WASHINGTON CITY
PLANNING COMMISSION MEETING
STAFF REVIEW

ACTION REQUESTED: C-26-05 - Request for a Conditional Use Permit to redevelop the commercial property located at 910 west and 912 west Red Cliffs Drive

ACTION REQUESTED: C-26-06 - Request for a Conditional Use Permit to develop the commercial property located at 1309 E Twin Rocks Cove

ACTION REQUESTED: G-26-02 - A request to amend the General Plan Land Use Map from LD to NCOM located at 362 W 3650 S

SITE PLAN
GREENS SPRING SQUARE
LOCATED IN WASHINGTON, UTAH

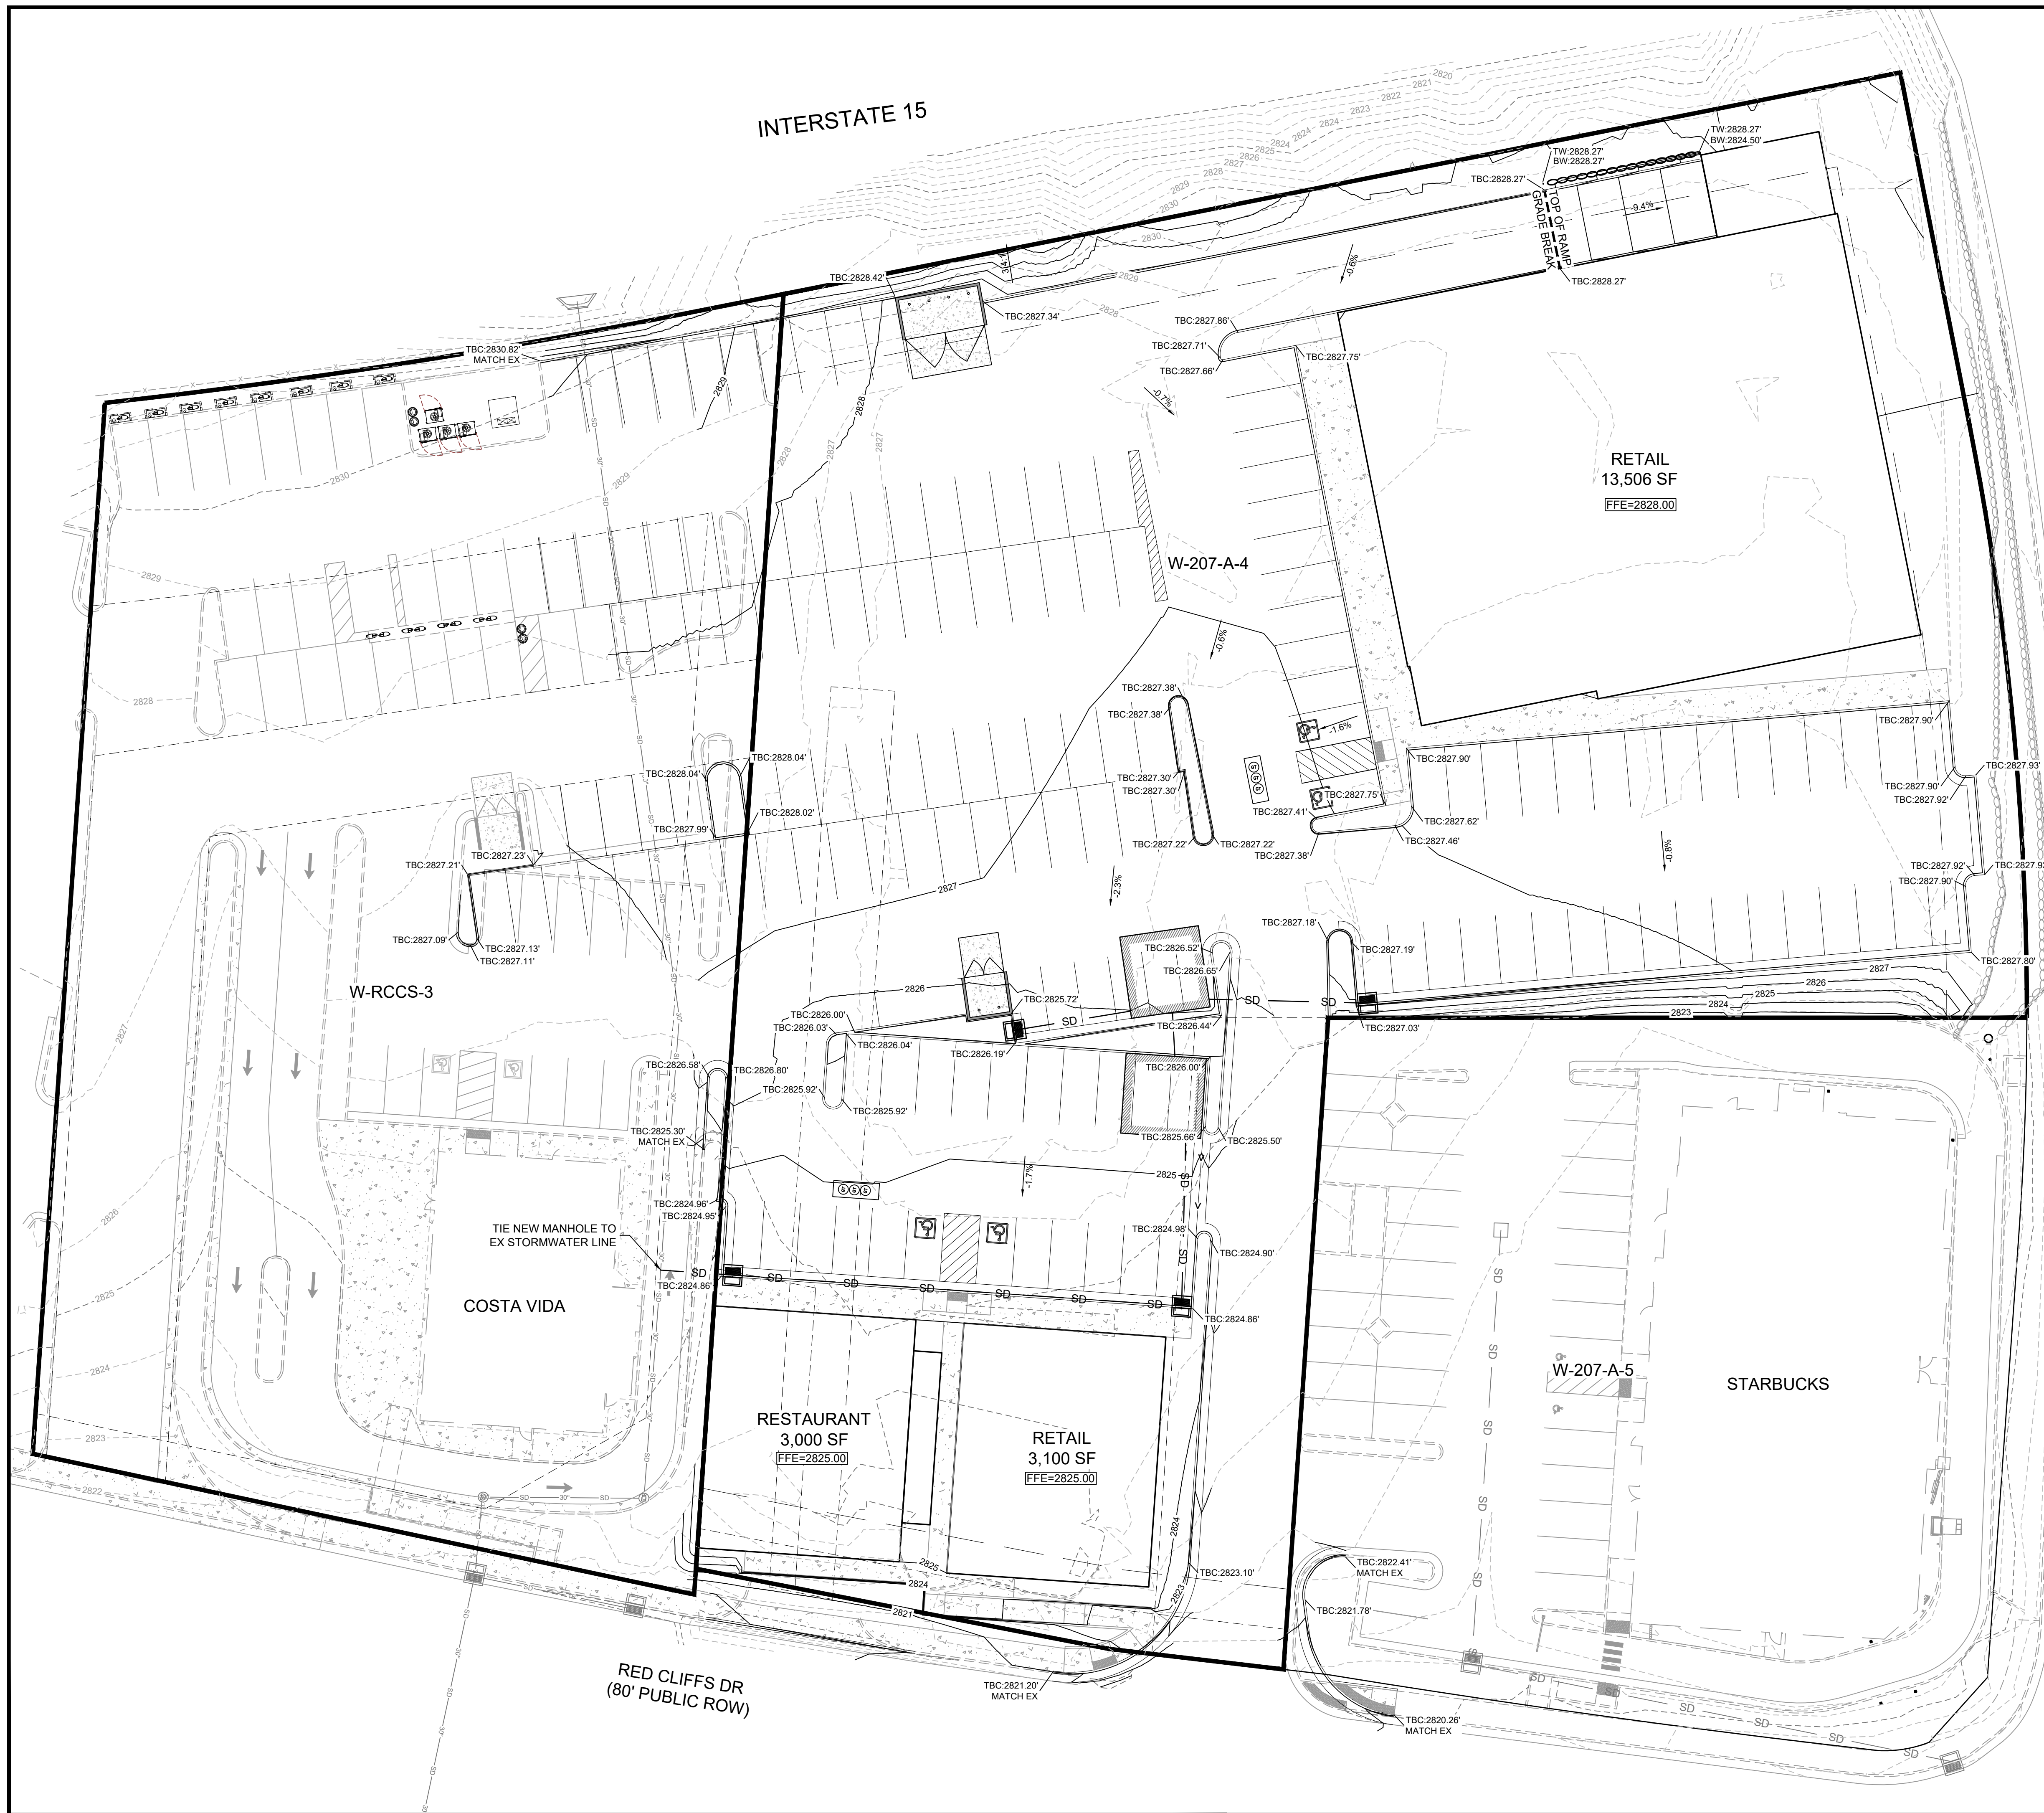
The required setback adjacent to Red Cliffs Drive is 20' feet. The applicant is encroaching this setback which will need to be approved by the City Council. The property line is angled at this location with the closest part of the building being 11' feet from the back of sidewalk (5' ft to property line) and 16' feet 5" inches to the farthest property line. The required side yard setback is 10' feet. The applicant is encroaching this setback which will need to be approved by the City Council. The proposed restaurant is showing a side yard setback of 0' feet. Staff understands

The proposed buildings require a total of 87 parking spaces. The proposal is providing 117 parking spaces 16 of which are for compact cars. The proposed parking is providing an excess of 30 parking spaces. The applicant is working on, and will be required to provide, a shared access agreement from the proposed development through parcel W-RCCS-3 which is where Costa Vida is located. This will allow better vehicular access from Red Cliffs Drive to the proposed development.

12. Proposed buildings shall not encroach any of the existing utility easements. The existing gas easement shall be vacated prior to issuing the restaurant building permit.

13. The applicant is required to provide a shared access agreement from the proposed development through parcel W-RCCS-3 prior to issuing the first building permit.

14. The setbacks are approved as shown on the plan.

SITE PLAN FOR
HUEY MAGOO'S, FIZZ DRINKS, & TENANT SPACE
PARCEL C, SIENNA HILLS SHOPPING CENTER PHASE I FINAL PLAT - AMENDED & EXTENDED
WASHINGTON CITY, WASHINGTON COUNTY, UTAH
1309 E Twin Rocks Cove, Washington, Utah 84780

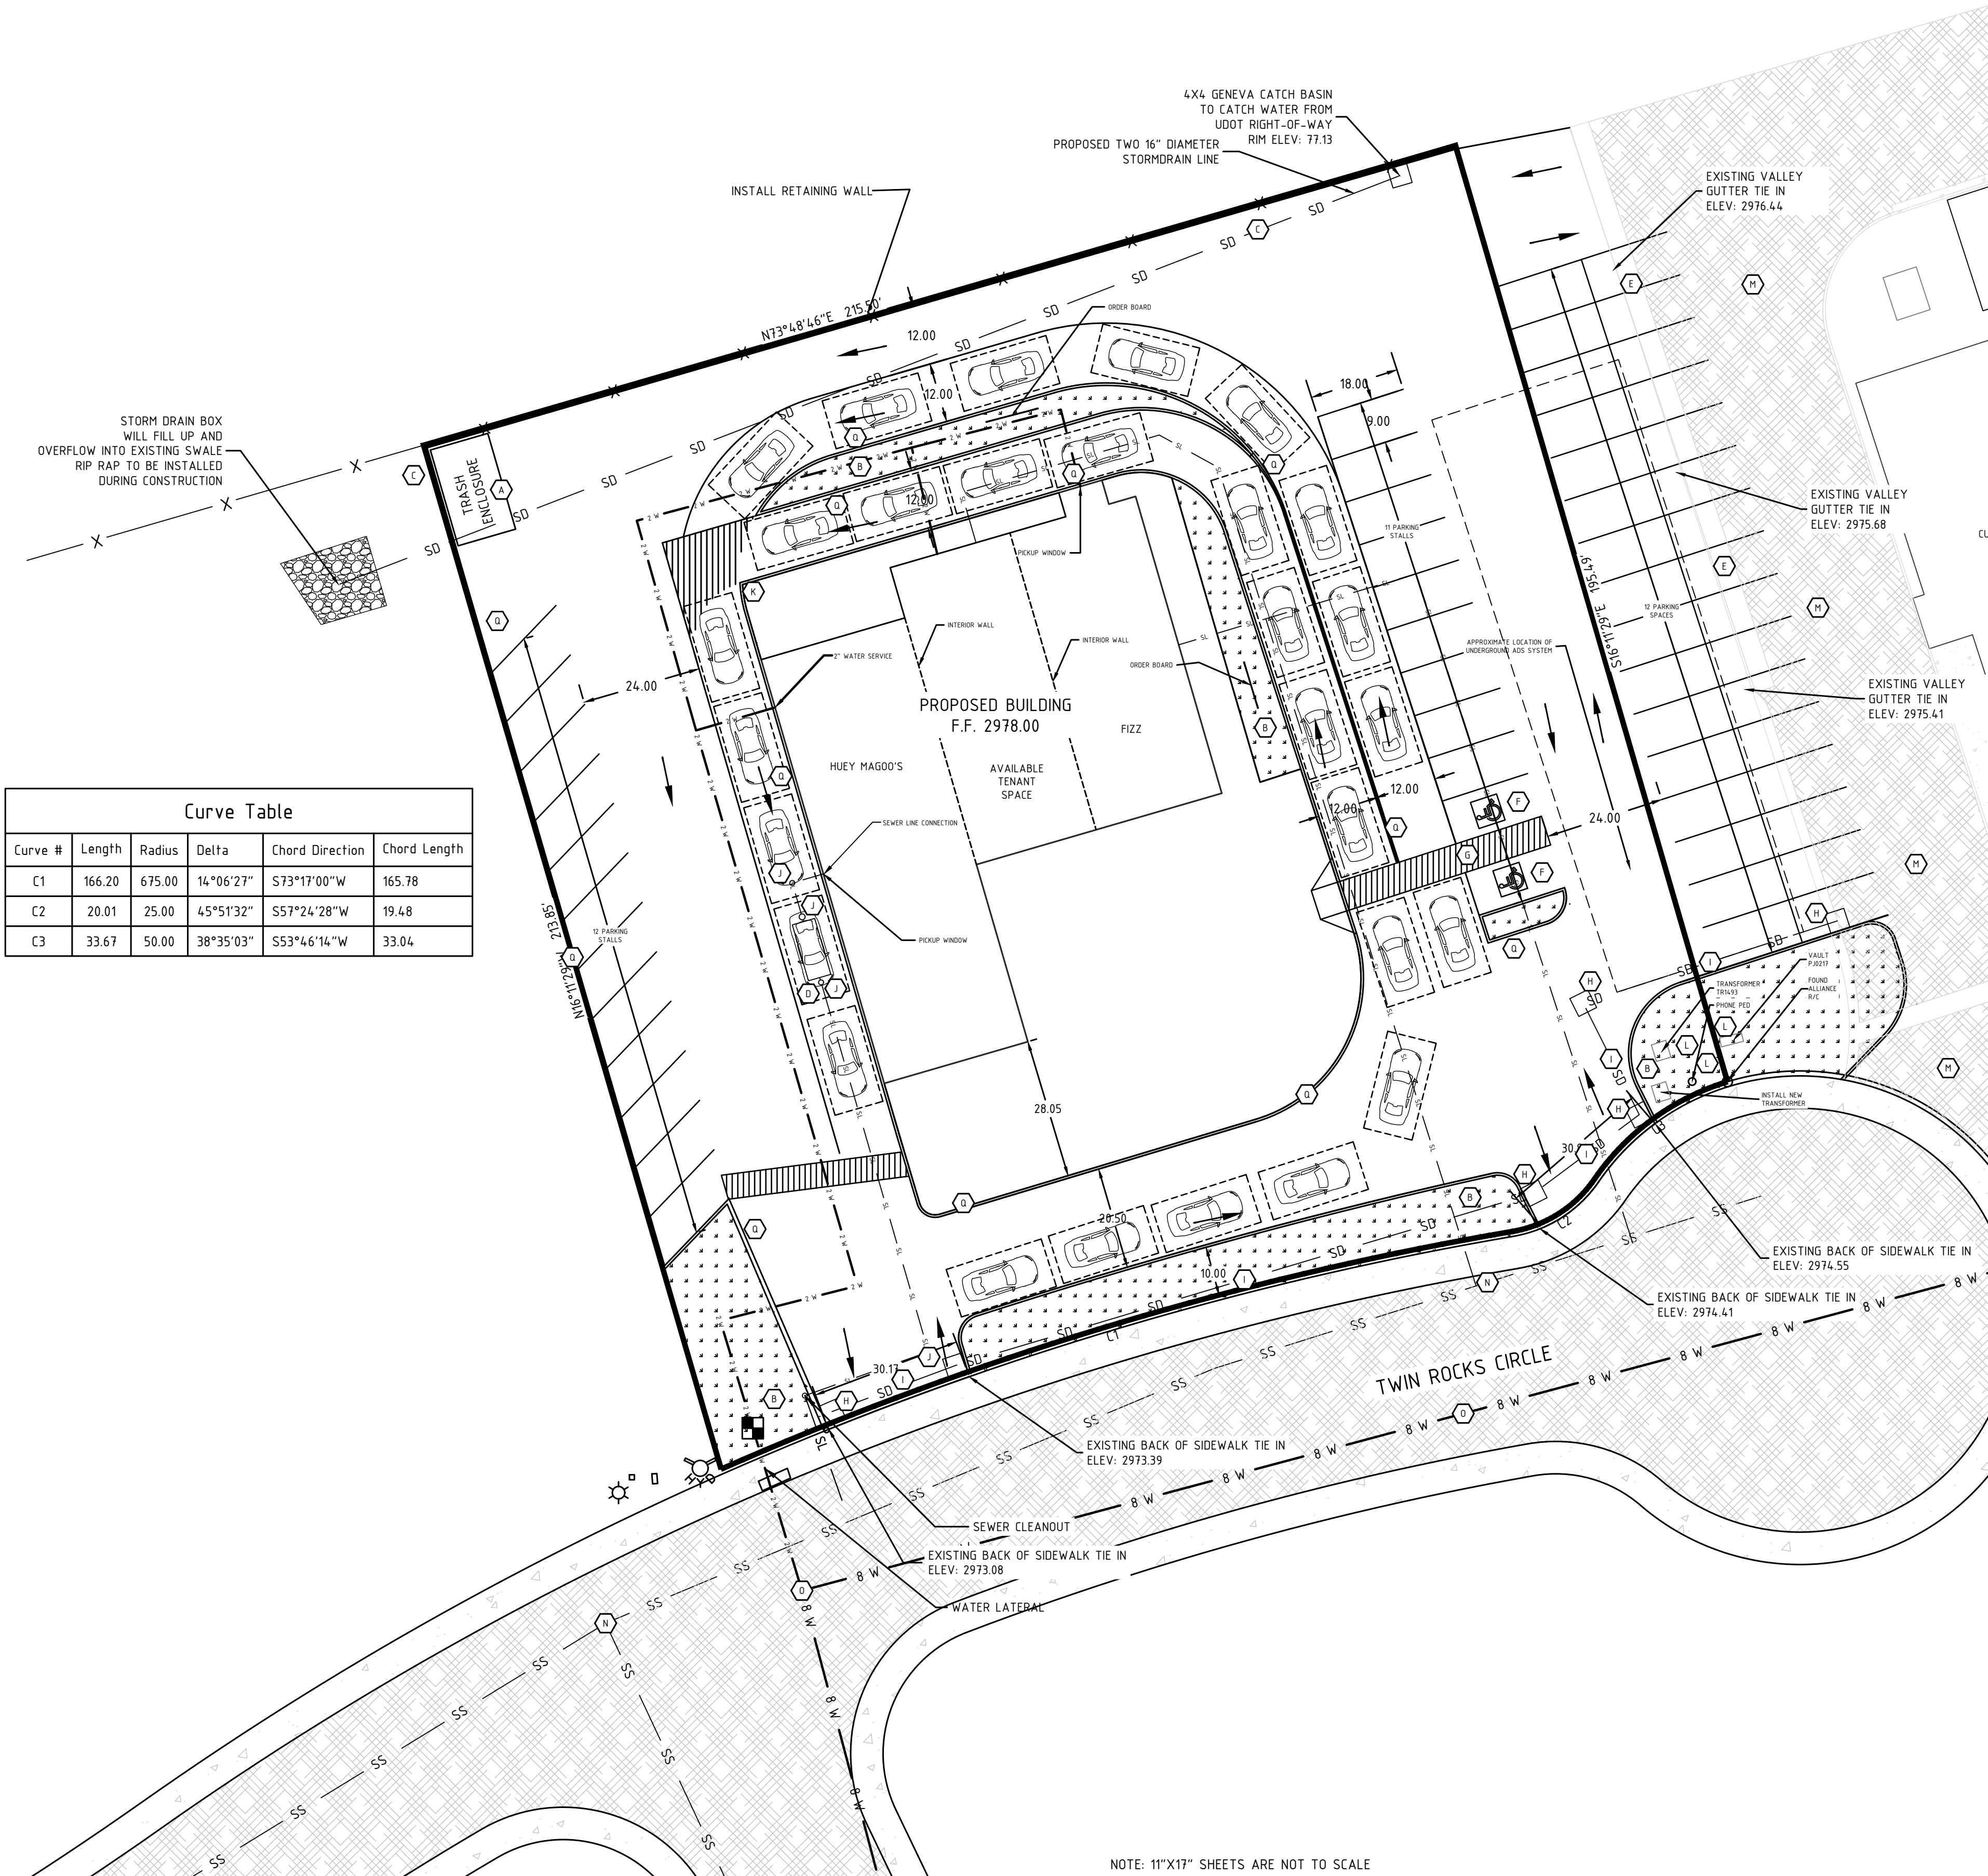
11. Construction drawings will need to be submitted for review and approval, prior to any work being done on the site. The applicant shall work closely with public works regarding the civil improvements for this development to ensure services are adequate and meet city requirements including the relocation of the shared parking. The west access point near the intersection of Twin Rocks and Hoodoo Way will require additional study and may need to be removed or revised to an exit only to help with traffic at the intersection.

12. Three landscape islands, with trees and live growth plants, shall be incorporated into the plan at the north end of the three proposed parking rows. This shall be verified during the Construction Drawing review process.

13. The applicant is required to provide a shared parking agreement with the development to the east. This agreement needs to be recorded at the county and verified with the Construction Drawing review process.
